Laxá Hydropower Scheme, Iceland

Review of Sediment and Ice Challenges

LV report no: LV-2013-112 **Date:** 02.10.2013

PROJECT	Laxá Hydropower Scheme, Iceland	DOCUMENT CODE	125214-100-HAST
SUBJECT	Review of Sediment and Ice Related Challenges at Laxá Hydropower Plants Based on Haakon Støle's Field Visit 17-23 June 2013	ACCESSIBILITY	Open
CLIENT	Landsvirkjun	RESPONSIBLE UNIT	1087 Hydrologi
CONTACT	Andri Gunnarsson

Figure 5: Layout Intake and part of Laxá III dam (more or less as-built)

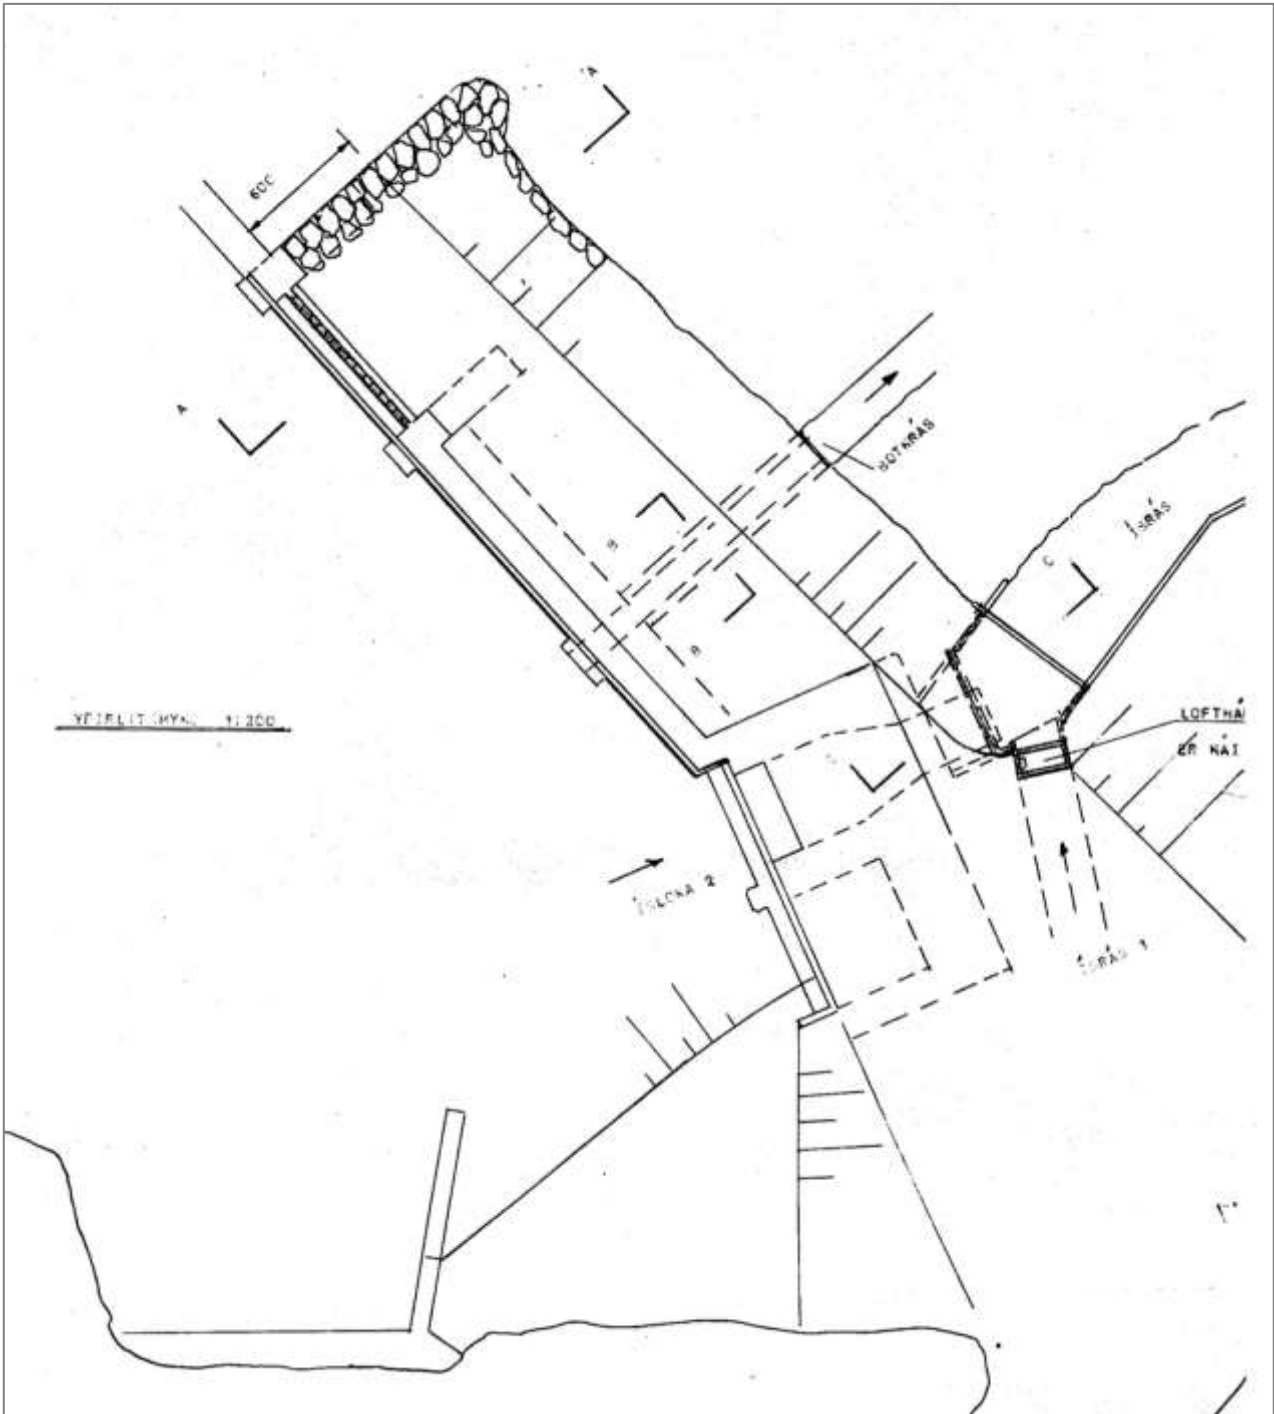
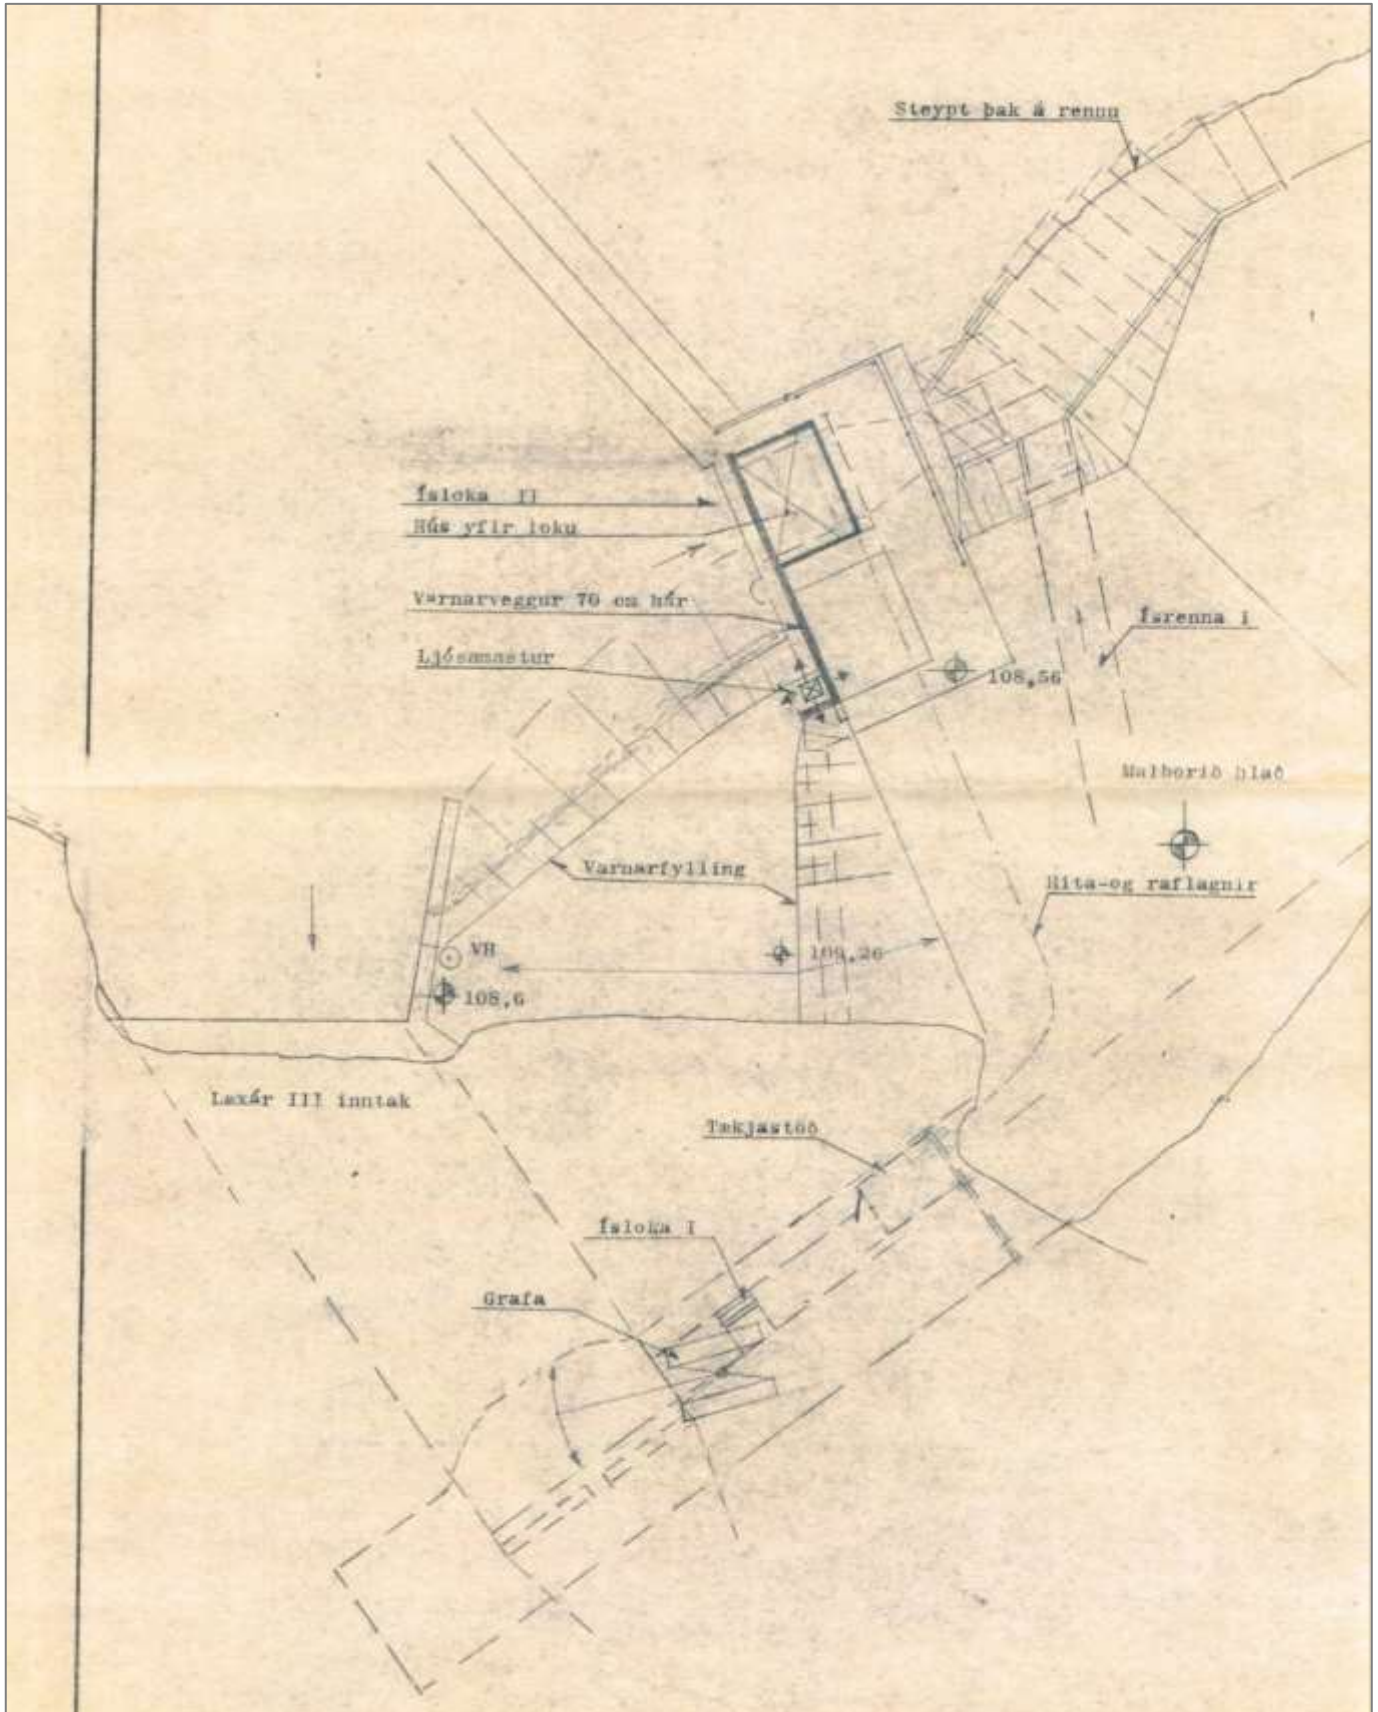
The bottom outlet gate (width: 1.25 m, height: 2.00 m) just upstream of the overflow gate at the original intake site is shown in the drawing in Figure 5, but not on Figure 6. The hoisting mechanism was damaged as seen in Figure 10, and it was not clear if the gate could be operated again. The

downstream side was closed by an embankment. It is not clear whether it is possible to reactivate this gate and use it for sediment flushing, see also Figure 30.

Figure 12: Layout and Sections of Laxá II Dam (Ref. 3)

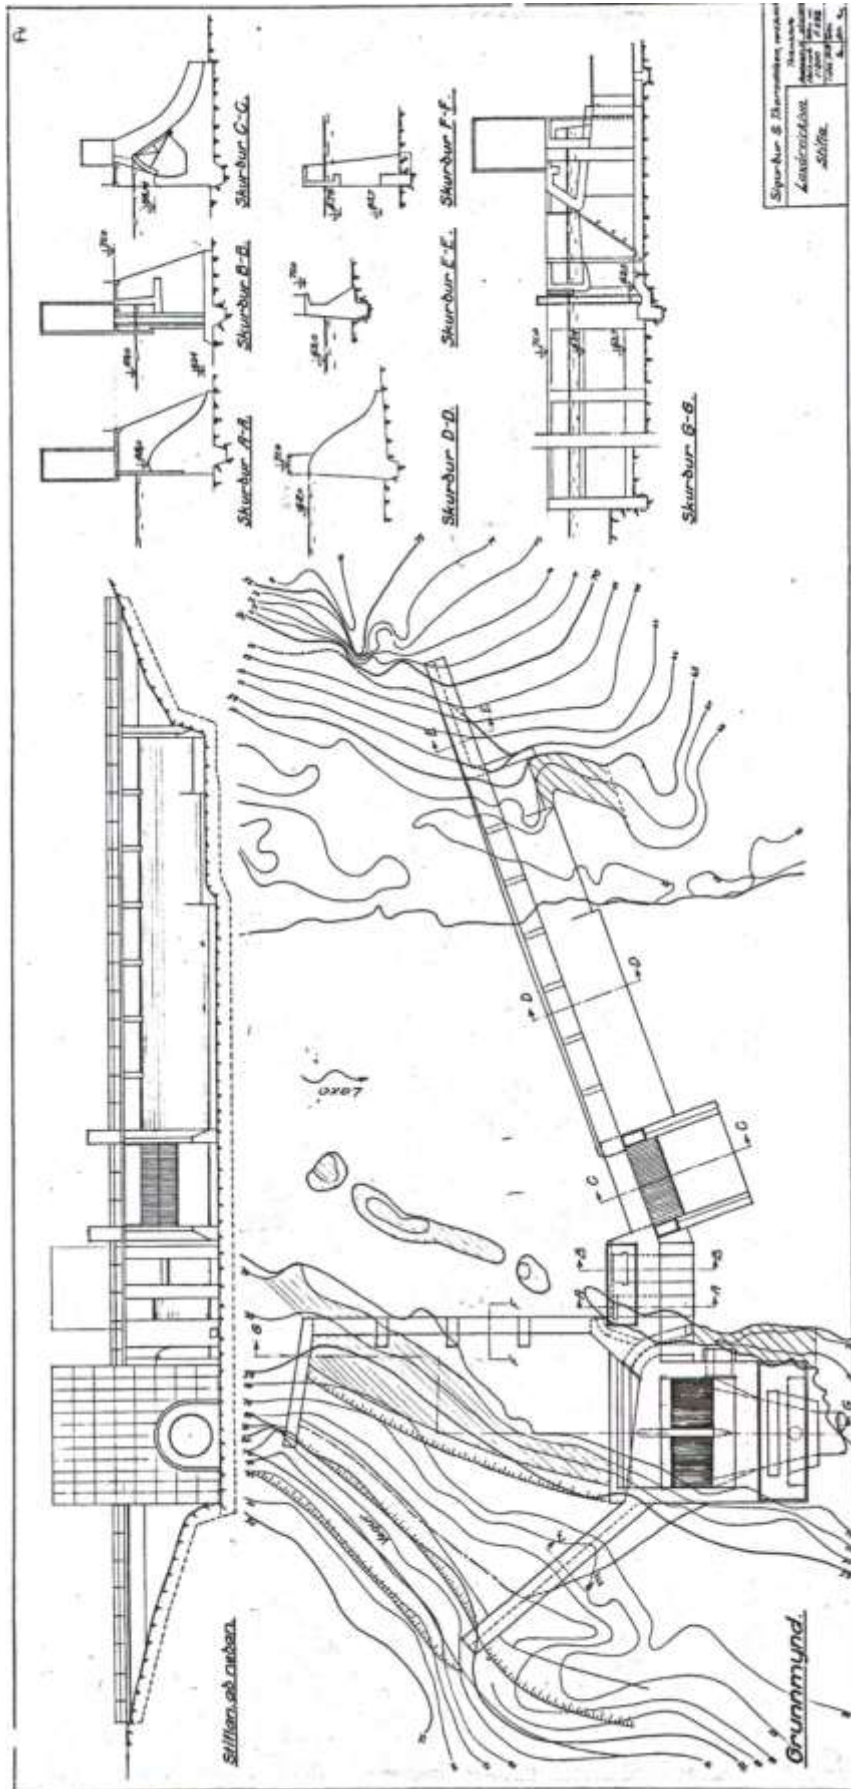
There are several facilities for release of surface water at Laxá II dam when the water level is just below the crest of the dam. Two of them are gated sluices. These are shown in Figure 12 in Section A-A which, is one of the two gates under the gate-house and referred to as ísyfirfall in [2], and Section C-C, referred to as Flóðgátt in [2]. These gates will be referred to as the ice-sluice which has a sill at elevation 68.0 masl and a width of 2 m, and the flood-sluice with a sill at elevation 66.5 masl and a width of 8 m. Reference is also made to Figure 15 where these outlets can be seen in the upper left corner. The flood-sluice gate is an overflow gate while the ice-sluice gate is an underflow gate.

Figure 24: Longitudinal section of the waterway as designed for the Laxá III high dam

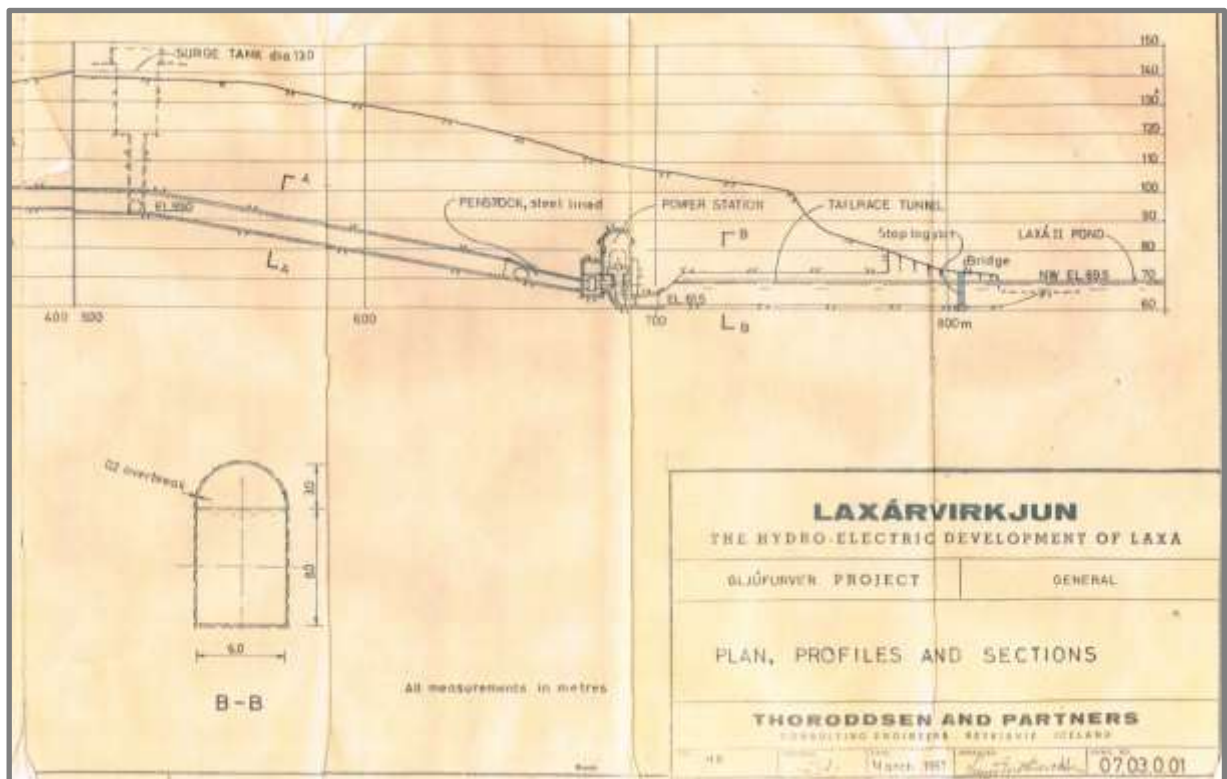
The drawing Figure 4 is extracted from shows also a longitudinal section through the waterway. This is shown in Figure 24. The plan included a “superstructure” on top of the surge shaft which would prevent surface water to enter into the surge chamber. Figure 25 shows the present situation on top of the surge chamber which also is an unfinished structure. There is no structure to prevent material from sliding into the surge chamber during snow melt or heavy rains. Ground water is furthermore drained into the surge chamber through cracks in the rock. The ground water will freeze as it is subjected to the air temperature during winter and ice bodies will form and be hanging from the side walls until they become so heavy that they break off and fall into the surge chamber. Pieces of rock may break off and fall into the surge chamber together with the ice.

We recommend Landsvirkjun to start the work as soon as possible on safeguarding the surge chamber and thus prevent intrusion of snow, ice and sediment into the chamber and the waterway of the plant which may cause an emergency shutdown of Laxá 3 hydropower plant.

Figure 30: Drawings of bottom outlet gate and a closed bay in the Laxá III dam

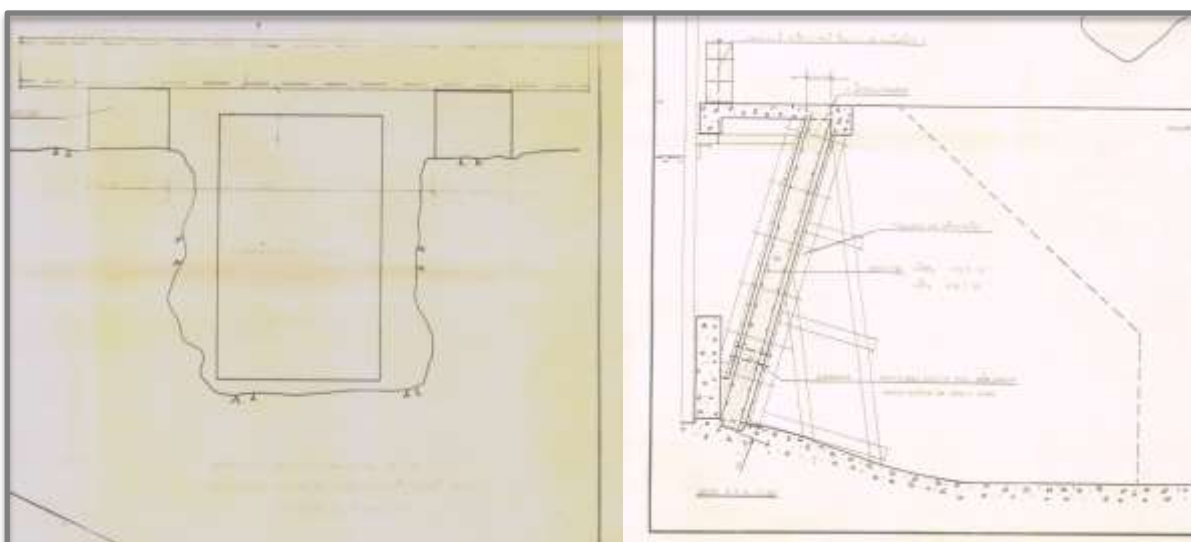
The low level gate in the dam (shown in Figure 10 and Figure 30), which is the simplest and to most outsiders, the first choice for flushing sediment deposits from the head-pond of Laxá III dam, has not been used to flush sediment deposits during the time Landsvirkjun has operated the plant, may be never(?). Since Laxá 3 was constructed, the diversion tunnel has been the designated tool to flush sediment because the high dam would come sooner or later and the bottom outlet gate in the dam could then not be used. So it has been deactivated rather than upgraded for flushing purposes.

It was not possible to find complete drawings and other relevant information on the Laxá III dam as it is today. Ref. 2 includes no drawings of the dam and the intake arrangement, except the overall layout drawing shown in Figure 1 and 2 and a section drawing of the ice-sluice. It is likely that more information are available somewhere in the system (as shown in Figure 30), but undocumented modifications has most likely been implemented, the hoisting arrangement at ísloka II shown in Figure 9 which is different from the drawing shown in Ref. 2 is an example of that. Two drawings of components of the Laxá III dam found at Landsvirkjun's office in Reykjavik are shown in Figure 30.

There are two existing facilities which could be used for this, i.e. the bottom outlet gate and the bay closed with stop logs shown in Figure 8. The efficiency of using these two low level openings to flush sediment around and not through the intake will be very important information for designing a permanent and robust sediment handling method for Laxá III dam.

Before these outlets are opened, it is important that preparations are done so it is sure that it will be possible to close these facilities again properly after the flushing operation is completed.
